Landscape Response

Stonehouse Farm, Handcross Road, Plummers Plain, October 2025

Response to Landscape-related comments received on 23rd September 2025 in connection with planning application DC25/0403 at Stonehouse Farm, Handcross Road, Plummers Plain, West Sussex.

Figure 1.1 – Indicative update to southern boundary (to be considered).

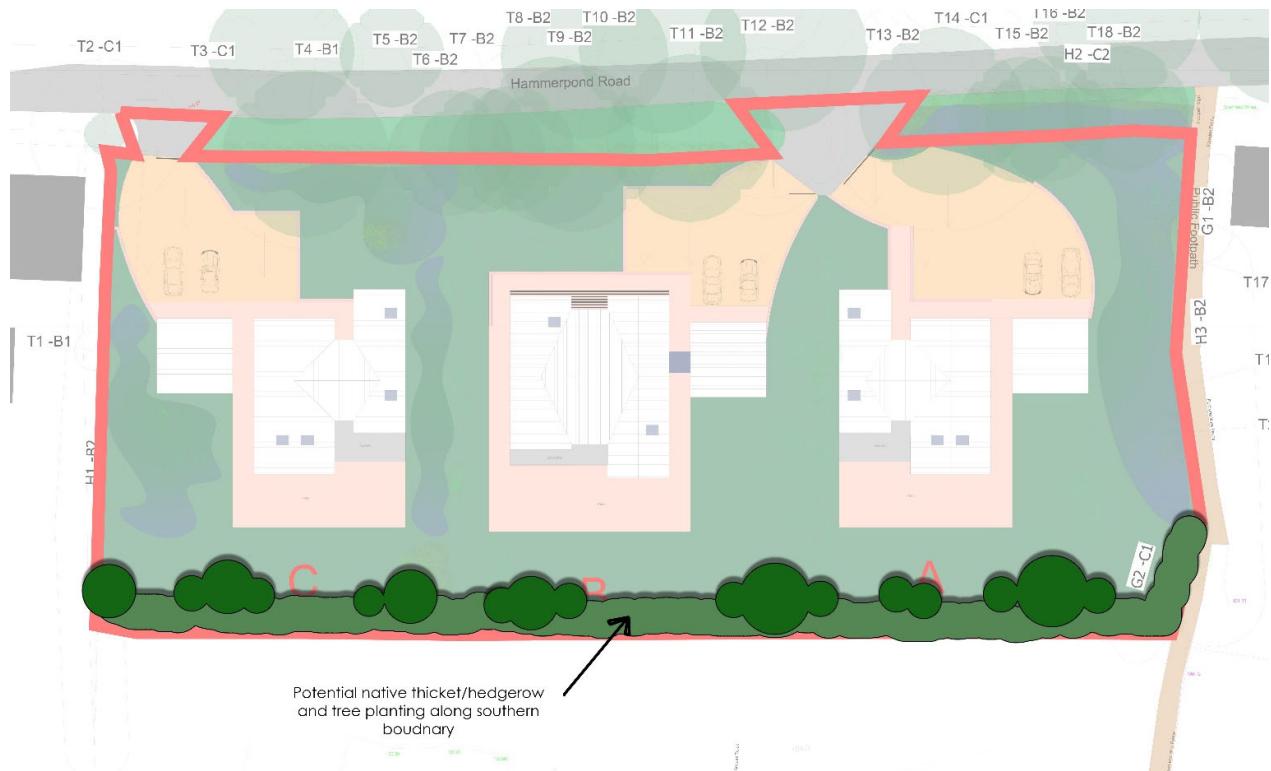
- 1.1 **Paragraph 30** of the Landscape Officer comments: *'To mitigate the visual effects discussed and enhance integration with the surrounding landscape character, hedgerow and hedgerow tree planting must be delivered along the southern boundary. This will contribute to softening the appearance of the development from the PRoW, Handcross road and the HWNL. Furthermore, to increase its mitigation benefits, this planting should be implemented as advance planting, to also reduce adverse effects during the construction period.'*

- 1.2 *'Not yet addressed. As discussed under point 24, advance planting along the southern boundary is required to mitigate the adverse effects identified. While we acknowledge the HMMP, as suggested within the Landscape Rebuttal, this information predominately relates to the soils and the planting palette, and is therefore not sufficient to secure advance planting locations. As such, locations of advance tree planting are expected to be submitted prior to determination to secure successful mitigation measures from the outset. The exact planting plan details can be secured via condition.'*

- 1.3 *'Not addressed. The mitigation strategy must be secured prior to determination, with planting details secured by condition.'*
- 1.4 As outlined in paragraph 1.3 above, the mitigation strategy will be secured prior to determination, with planting details to be agreed through condition. This should be discharged via a detailed Soft Landscape Proposals Plan, which will include a Planting Schedule and Planting Specification. These plans will set out information on plant and tree species, age, sizes, form, density, and quantities, along with general guidance on planting and landscape management.

Figure 1.1 below illustrates how the Proposed Site Plan (259101-110) could be updated to incorporate a slightly more robust hedgerow and tree planting strategy. This enhancement will address the original comment in **Paragraph 30** of the Landscape Officer's feedback: *'...hedgerow and hedgerow tree planting must be delivered along the southern boundary.'*
